**Consultation on Draft Masterplan, Land east of Bell Road, Bottisham**

**Summary of responses (April 2014)**

### Q3. Do you have any comments on the general layout of the site as shown on the Combined Parameters Plan and the Illustrative Layout (Part F)?

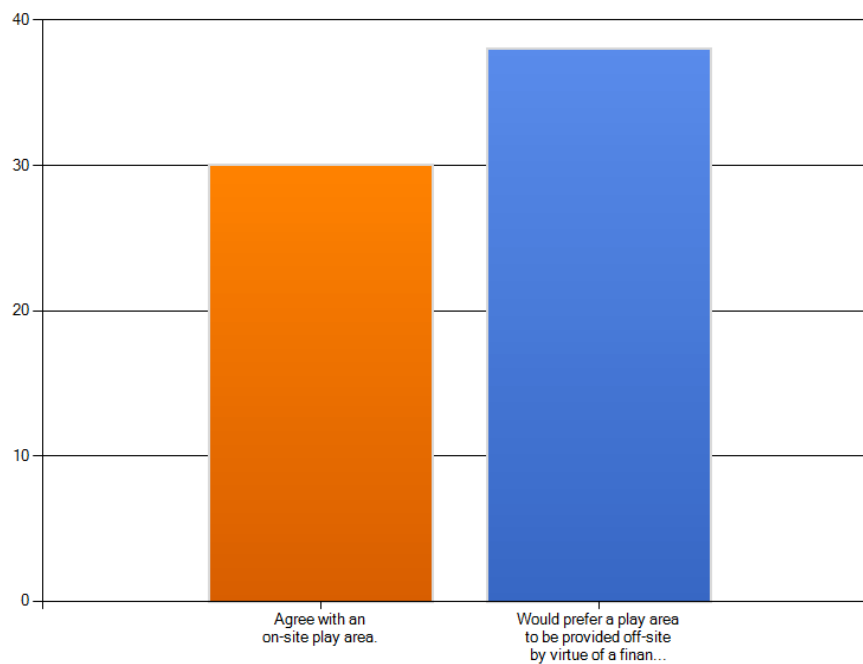
<b>Summary</b>	<b>Number of comments</b>	<b>Officer response</b>
Insufficient car parking – note problems in existing Ox Meadow development.	8	<p>As set out in the Council's Design Guide SPD, it should be assumed that the street is for vehicular movement, and cannot provide parking for new development, unless such space is actually identified within the development proposal for on-street parking. The Masterplan proposes that parking provision will generally be provided in line with adopted standards.</p> <p>Propose amended text on page 41:</p> <p>'Provision should <del>also</del> be made for a small amount of casual visitor parking. This need not be in the form of <del>designated</del> allocated spaces, as the pressure for parking on this site is unlikely to be excessive, <del>but could simply be in the form of on-street parking</del>. Any on-street visitor parking should be integral to the design of the carriageway and not impede the free-flow of traffic'.</p>

Density is too high.	6	<p>Proposals should ensure they reflect the character (including density) of this rural village. See page 35 (density), page 37 (principles of placemaking) and Section D3 (Scale and Appearance). No change considered necessary to draft Masterplan.</p>
Insufficient play areas/site play areas in Green Belt.	3	<p>The majority of respondents indicated they would prefer to see a play area provided off-site. See response to Q4 below. This could be achieved by providing a commuted sum towards the upgrade of other play areas or the provision of a new play area elsewhere in the village. No change considered necessary to draft Masterplan.</p>
Query lack of direct access to A1303.	3	<p>CCC Highways have advised that the main vehicular access should be off Bell Road, via a spur off the access that serves St Peter's Field (subject to a Transport Assessment). No change considered necessary to draft Masterplan.</p>

Roads too narrow – issues with parking & emergency access	3	<p>This issue will be considered by CCC Highways as a statutory consultee once an application is submitted. No specific road widths are proposed by the Masterplan. As set out in the Council's Design Guide SPD, it should be assumed that the street is for vehicular movement, and cannot provide parking for new development, unless such space is actually identified within the development proposal for on-street parking. The Masterplan proposes that parking provision will generally be provided in line with adopted standards.</p> <p>See pages 38-40 (Movement Network) and page 41 (Parking Provision). Propose amended text on p41:</p> <p>'Provision should <del>also</del> be made for a small amount of casual visitor parking. This need not be in the form of <del>designated</del> allocated spaces, as the pressure for parking on this site is unlikely to be excessive, <del>but could simply be in the form of on-street parking</del>. Any on-street visitor parking should be integral to the design of the carriageway and not impede the free-flow of traffic'.</p>

Need parking for allotments to avoid exacerbating parking issues.	3	<p>The Masterplan provides for parking for the allotments.</p>
Too close to existing development/A14.	2	<p>Comments noted. No change necessary to draft Masterplan.</p>

<b>Summary</b>	<b>Number of comments</b>	<b>Officer response</b>
Support landscape corridor/pedestrian access to SAM and woodland.	1	Comments noted. See page 58/59 (Combined Parameters Plan) and p60/61 (Illustrative Layout). No change necessary to draft Masterplan.
Remove allotments.	1	The Parish Council has indicated a need for allotments within the village. No change necessary to draft Masterplan.
Suggest reduction in tree belt and less encroachment into Green Belt.	1	The site area is identified in the Council's emerging Local Plan for residential development and is proposed to be released from the Green Belt. The development needs to strike a balance between establishing an appropriate density and layout and minimising impact on the Green Belt and open countryside. See Section B5 (Green Belt). No change considered necessary to draft Masterplan.
